Item 6 – Review of Renovation Design Plans for the District Office

The Building Committee met on March 28, 2016 to discuss revisions made to the renovation plans for the District Office being developed by Harry Bostic. These plans are provided for your review.

EXISTING REFLECTED CEILING PLAN

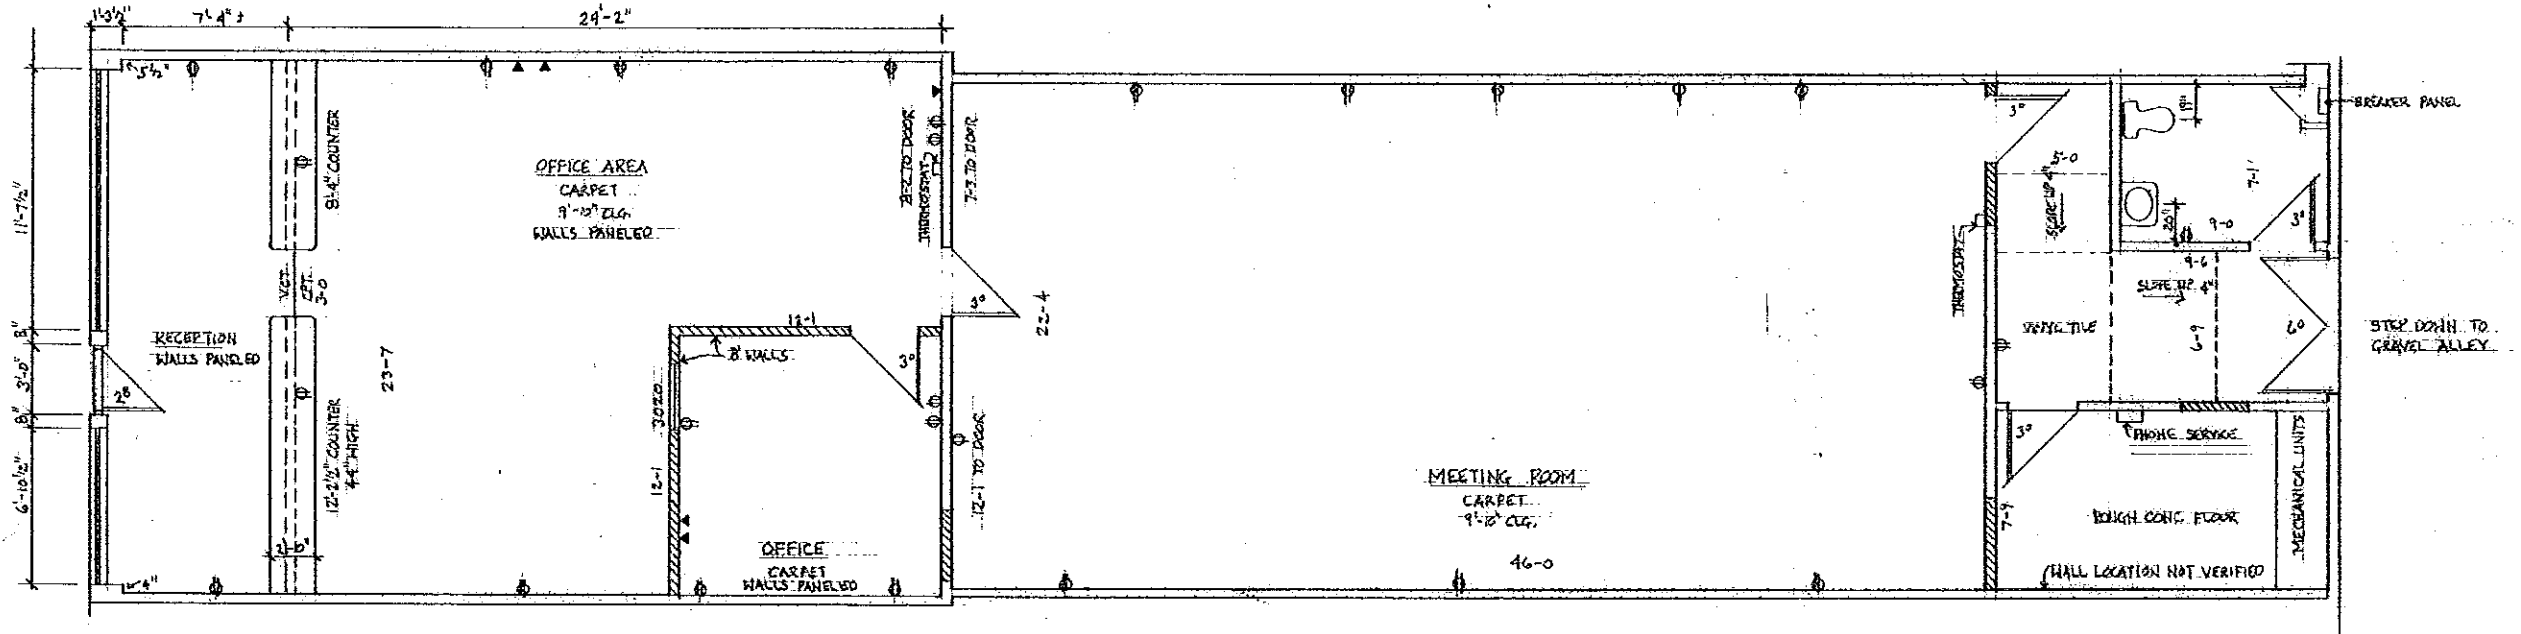
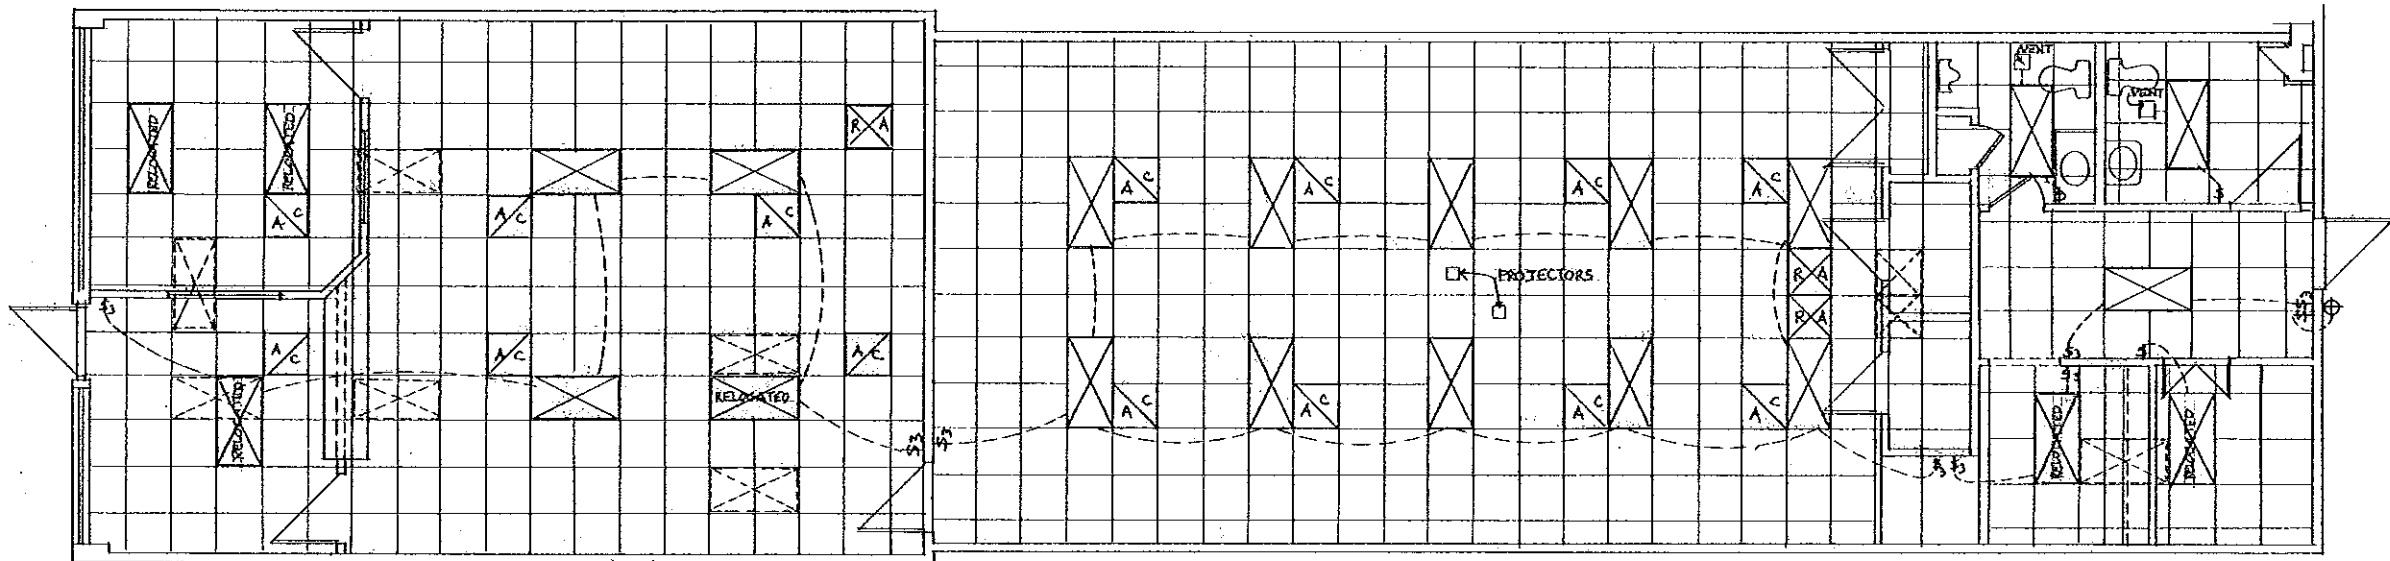
EXISTING LIGHT
 LOCATIONS THAT
 ARE BEING RELOCATED.

LIGHTS & A/C EXISTING
 LOCATIONS IN MEETING ROOM.
 RETURN AIR GRILLES RELOCATED

REVISED REFLECTED CEILING PLAN

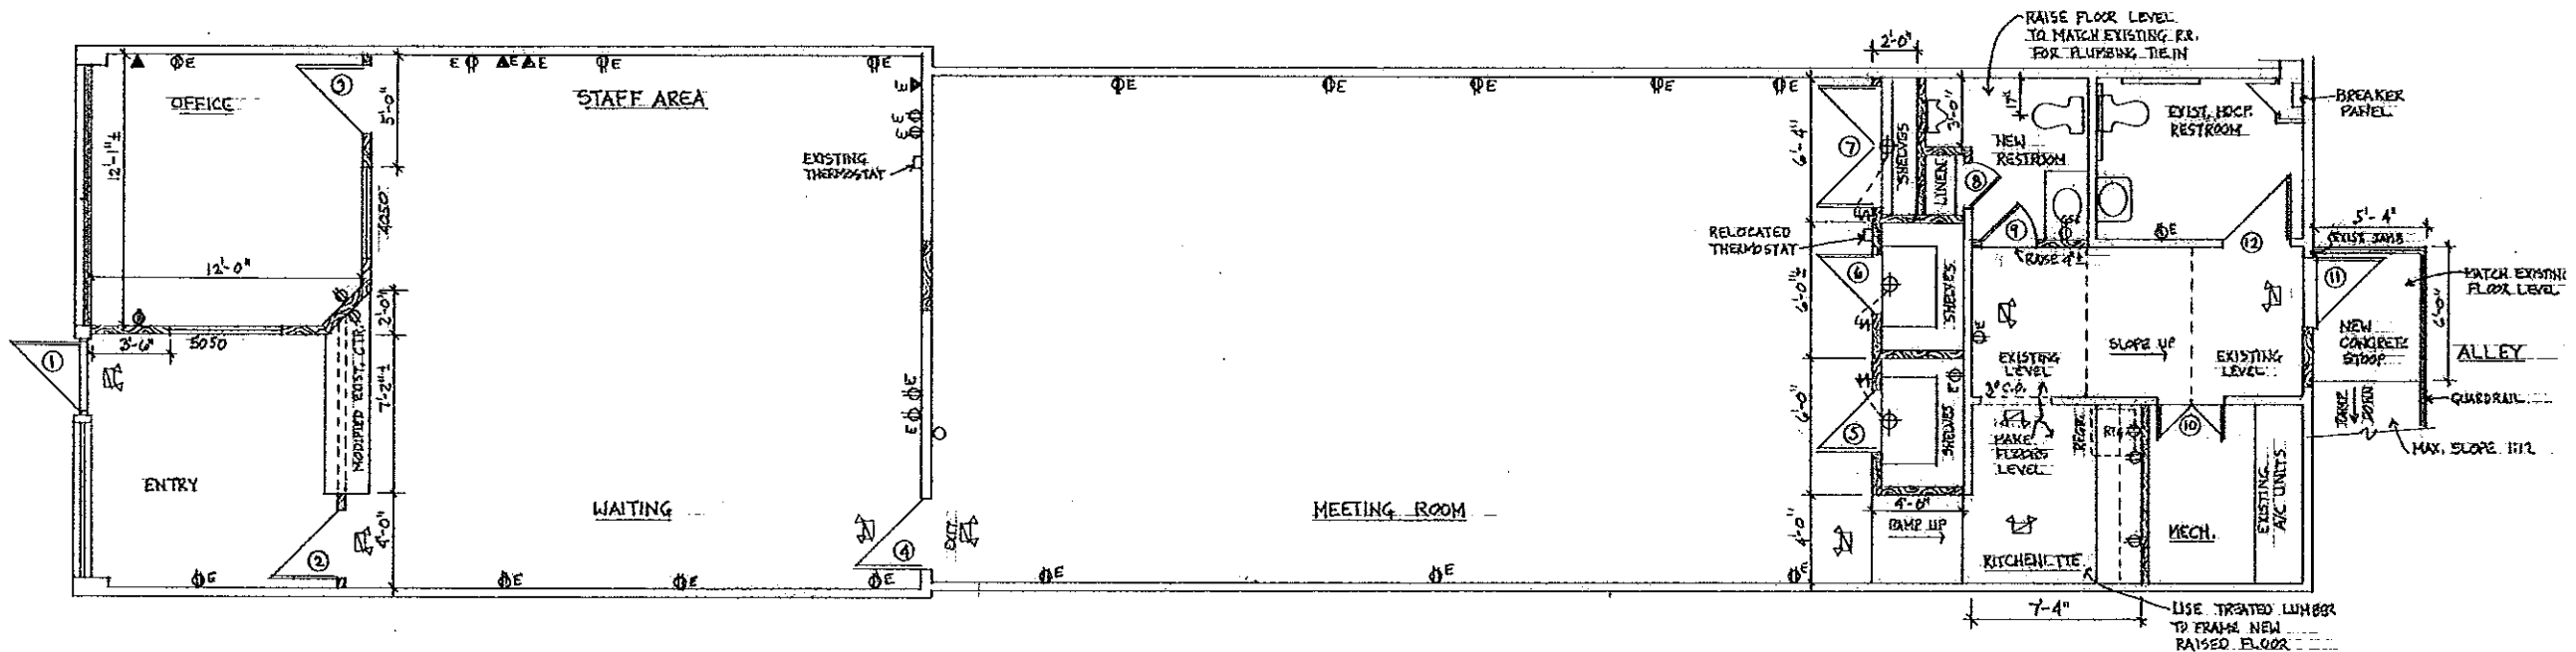
PROVIDE ALERT SYSTEM AT
 FRONT ENTRY DOOR.
 RELOCATE PHONE SERVICE AS
 REQUIRED. VERIFY NEW LOCATION.
